**A SECRETARY OF THE INTERIOR'S STANDARDS  
FOR THE TREATMENT OF HISTORIC PROPERTIES  
REVIEW FOR THE PROJECT AT 236 ELEANOR  
AVENUE, LOS ALTOS, SANTA CLARA COUNTY,  
CALIFORNIA**

**September 4, 2024  
(Updated November 7, 2024)**

**Figure 2. Sheet A5.2 shows the original windows that will be relocated and their proposed locations (Chapman Design Associates, 10/17/2024).**

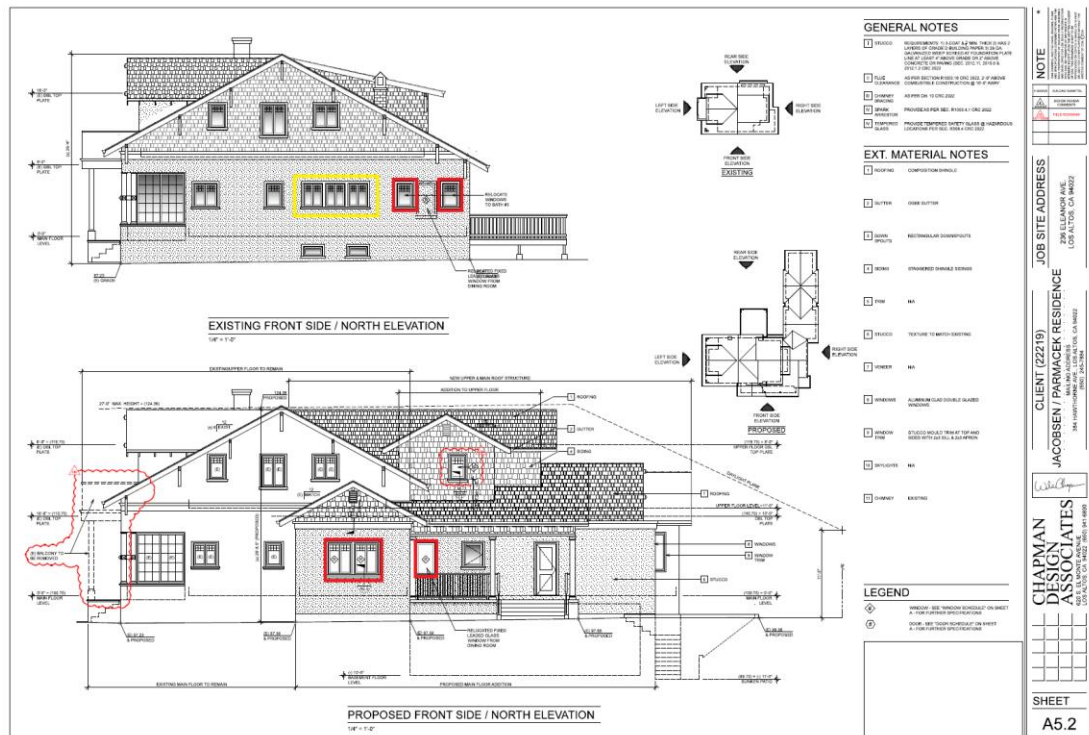
There are currently thirty-nine windows on the 1914 house. Twenty-two of these windows are original casement windows with a “valance-style” grid pattern consisting of eight-over-one glazing, three are original fixed windows with “valance-style” grids, one is an original fixed wood window with leading, and one is an original sliding wood window with two fifteen-light sashes. The new windows consist of three low-placed hopper windows, a ribbon of five, two-over-two, double-hung wood windows, and four four-light fixed wood windows. The Project consists of removing nine casement windows and replacing a fixed leaded window. The plan is to relocate six casement windows and the fixed window with leading. The relocated windows are enclosed in red, while the windows that are being removed without relocation are in yellow (Figure 2, Figure 3, and Figure 4). The proposed location of these windows does not promote a false sense of history and allows the retention of historic materials and character-defining features.

Overall, the Project retains approximately 90% of the original exterior stucco cladding on the north, south, and east elevations. It will also retain thirty (30) of the wood windows in their original locations and six original wood windows in appropriate locations within the 1914 house.

**Retain and Reuse of Historic Windows:** EDS recommended retaining several of the wood windows that would have been removed. The windows will be retained in situ or relocated within the 1914 house rather than removed.

**Figure 5. Sheet A5.0 shows the proposed removal of the balcony and the new fenestration (Chapman Design Associates, 10/17/2024).**

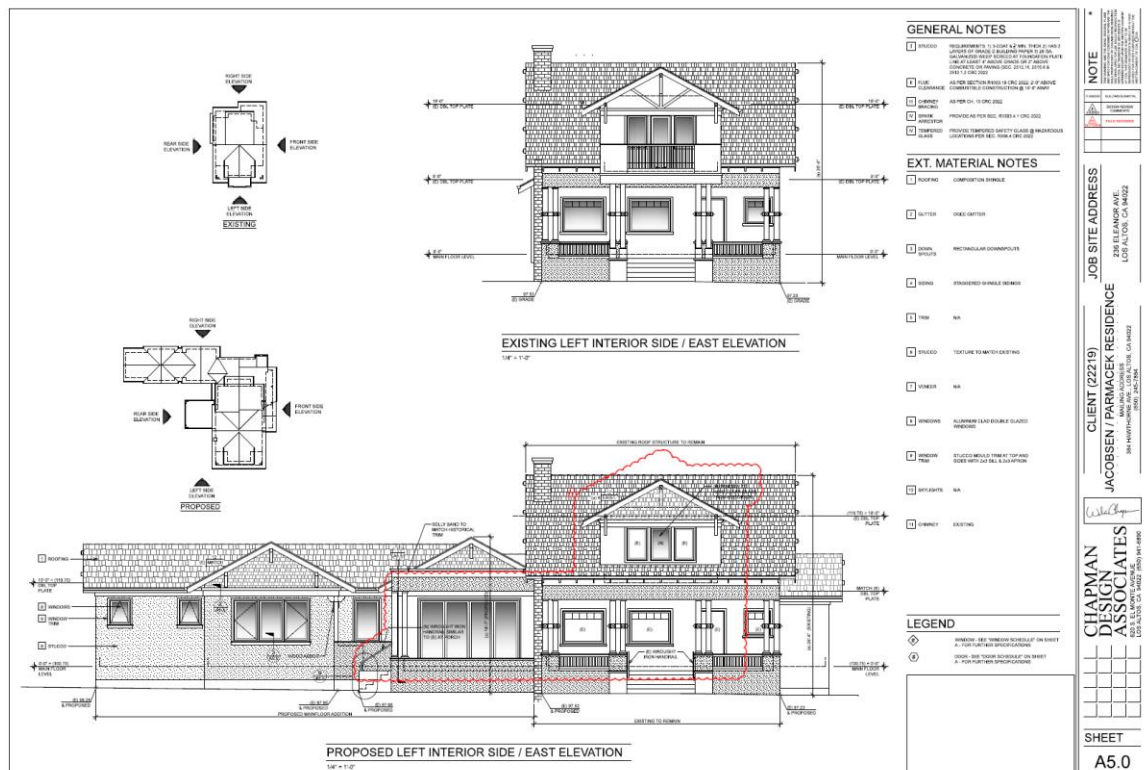
The second-story balcony of the 1914 house consists of a stucco-finished balcony with a central wood baluster. Two pairs of wood columns replicating the incorporated porch support the balcony. In the 1990s, these columns replaced two double wood brackets. As such, the second-story balcony is not historic and detracts from the original 1914 craftsman form. The door to the balcony will be replaced with a wood casement window (Figure 5). Removing this balcony restores the primary façade to its original 1914 Craftsman form, and removing the 1990s balcony restores the original design.

*EDS Analysis: The current Project designs, including changes to the primary façade balcony, fenestration, and decorative details were altered to meet the Standards further and retain or restore the house's character-defining features, including the side-facing gable form, wood windows, brackets within the gables, brick exterior chimney, and stucco finish.*

*Following recommendations by EDS, the new design by Chapman Design Associates (10/17/2024) includes retaining additional wood windows that will be relocated within the 1914 house rather than removing them and altering the design of the new second-story balcony addition on the south elevation – removing and the bulkier forms of the additions and creating a more compatible massing, size, scale and features. Removing this balcony restores the primary façade to its original 1914 Craftsman form, and removing the 1990s balcony restores the original design.*
